SSD-9138102 – Amended Report for Westlink Industrial Estate

Thank you for providing Penrith City Council with the opportunity to comment on the proposed amendment to the abovementioned State Significant Development (SSD) application. Council has reviewed the applicant's Amendment Report, dated 21 October 2022 for Westlink Stage 1, and the accompanying plans and reports and provides the following comments for your consideration.

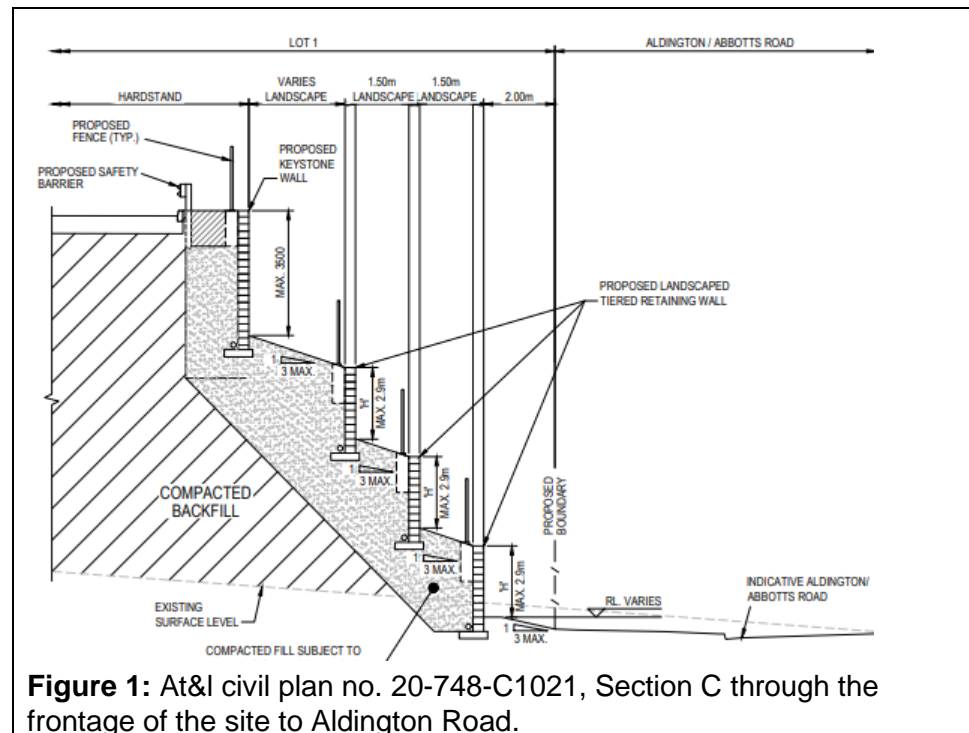
Figure 1 demonstrates that canopy tree planting at the upper-level truck hardstand is not possible as insufficient area is provided to allow this to occur.

Figure 4: Section E (through the frontage to Aldington Road) of the landscape plans indicate no planting at the top of the wall against the truck hardstand and large trees in narrow walls.

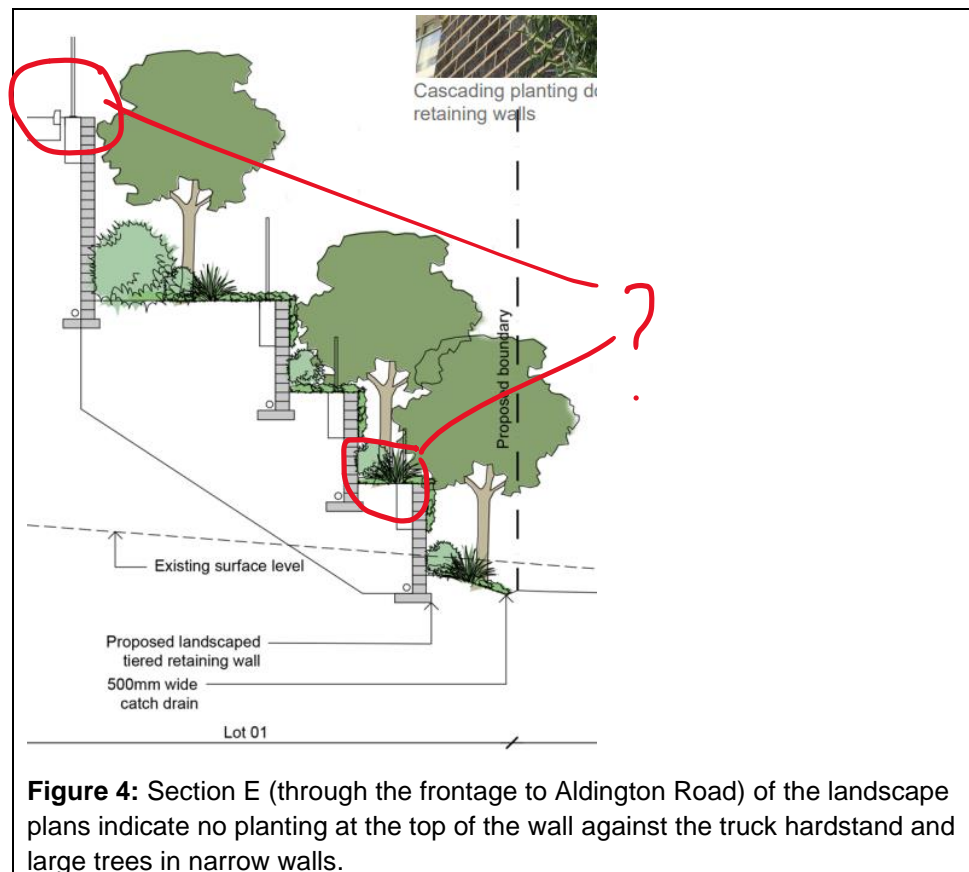
No minimum dimensions are provided to inform the width (or minimum widths) of landscaped area, between retaining walls, or between the hardstand truck manoeuvring area and the guard rail and the upper most retaining wall tier.

The applicant must confirm what the minimum width for each area is.

A 1.5m wide planter within a tiered retaining wall cannot support the selected canopy trees to maturity.

Figure 5: Northern boundary setback for landscaping is proposed to be a total of 2.5m (min.) inclusive of 800mm landscape berm and a 1.7m wide hard surface area comprising of a catch drain, retaining wall and fencing.

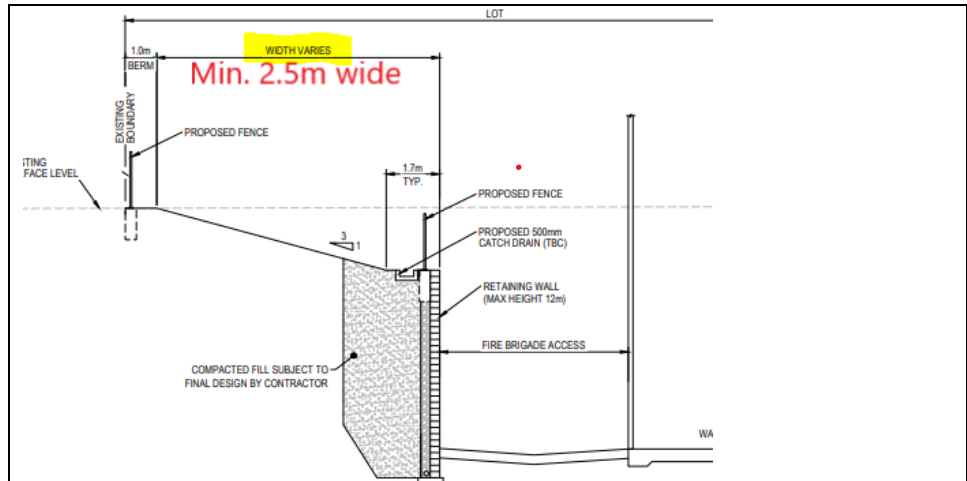
The canopy target plan indicates canopy tree planting along the northern boundary is proposed within an 800mm wide landscaped area located within the compacted fill area, along the boundary as per **Figure 5** and **Figure 6** below.

The applicant has not demonstrated that the proposed canopy targets for Stage 1 are achievable. The Canopy Tree Plan is incorrect.

Viewpoint 3 of the VIA is incorrect for the reasons provided in relation to Figure 5 and Figure 6 as canopy providing trees are not sustainable if planted within a boundary setback being 800mm wide at the top of a retaining wall.

- The plans for the development are to be amended to set back off the boundaries to provide the proposed canopy trees sufficient area to grow and thrive.
- It is calculated that the proposal includes excess parking beyond the minimum needs of the DCP of approximately 50 car parking spaces. It is recommended that in replacement of additional car parking spaces, larger areas for meaningful and sustainable stands of canopy trees are provided.
